elm creek Watershed Management Commission

AGENDA Technical Advisory Committee March 9, 2022 | 9:30 a.m.

Technical Advisory Committee Meeting Minutes February 9, 2022

1. Third Party Review of the Preliminary HUC-8 Model of the Elm Creek Watershed by Stantec dated January 22, 2021

Figure 1 Annotated Subwatershed Figure Reflecting Subwatersheds with No Modeled Storage or Only On-Channel Storage

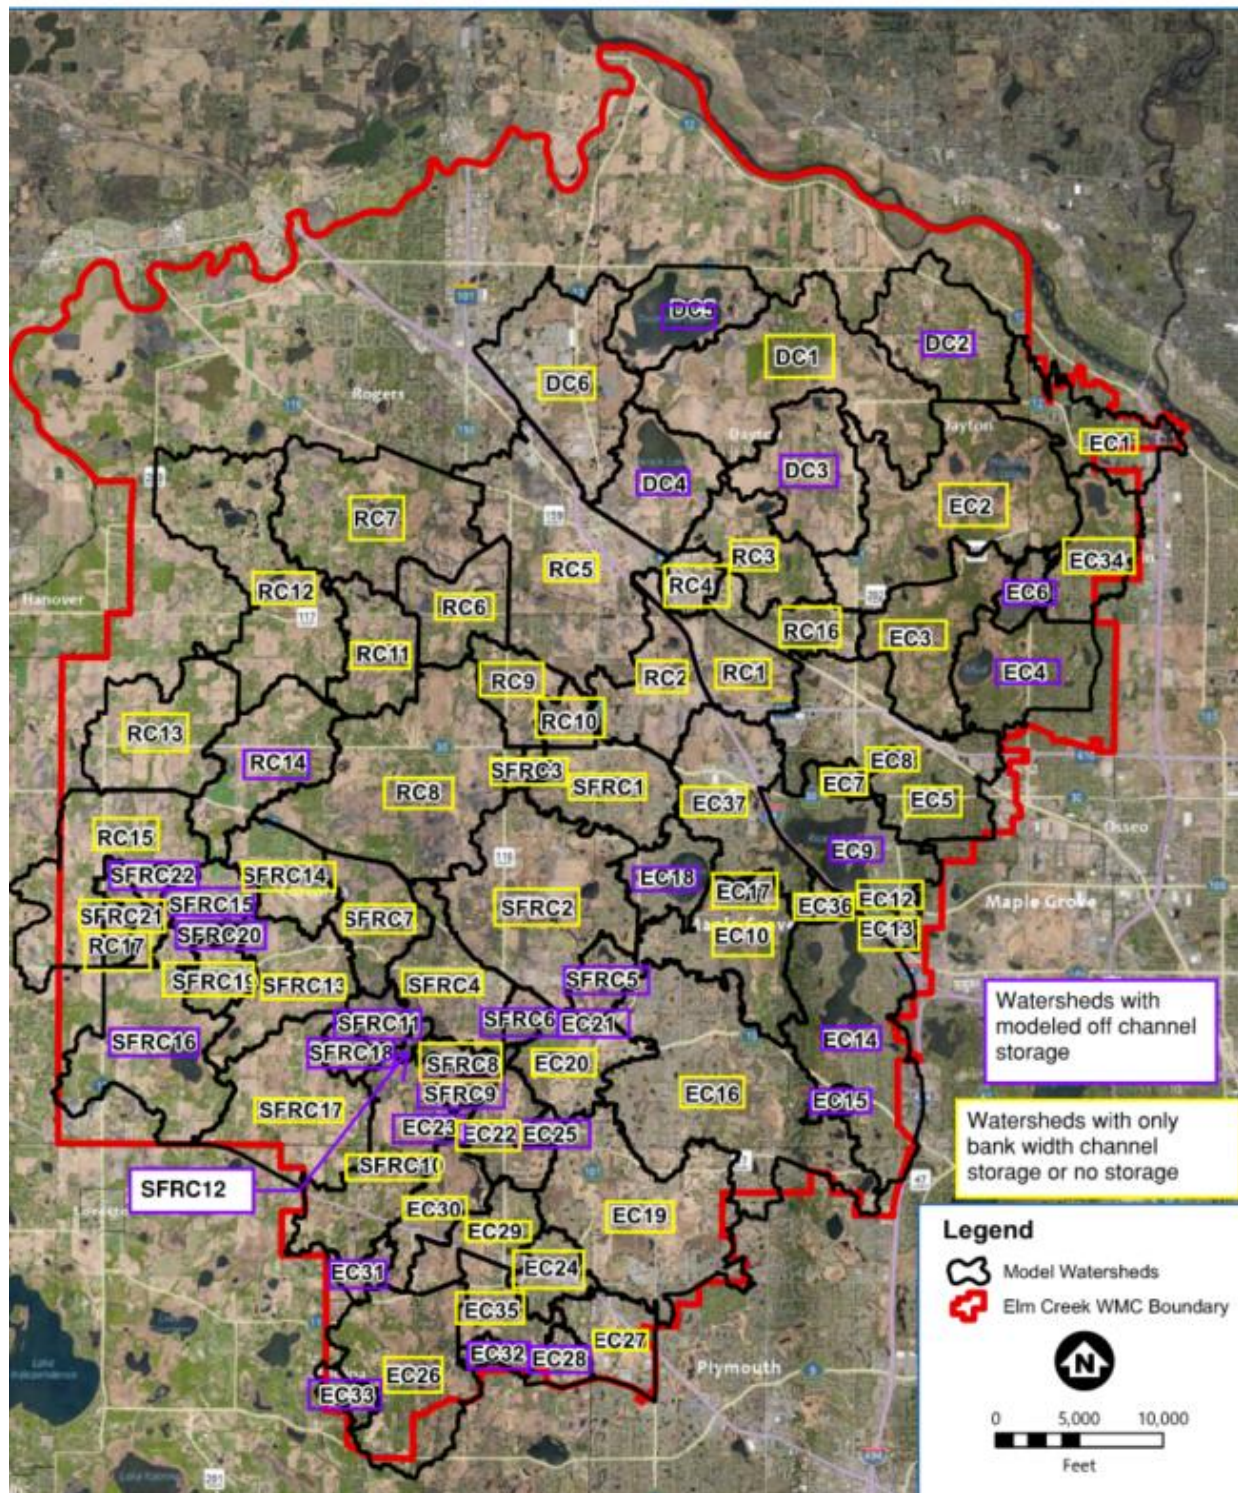
Table 2 highlights a few locations where the modeled approach is significantly undercounting for a significant flood storage volume as it only simulates on-channel storage for most of the watershed. The locations identified in Table 2 are not meant to be exclusive and are provided for illustrative purposes only. An annotated figure showing the locations where the Preliminary HUC-8 uses only channel storage or does not reflect any modeled storage is included as Figure 1.
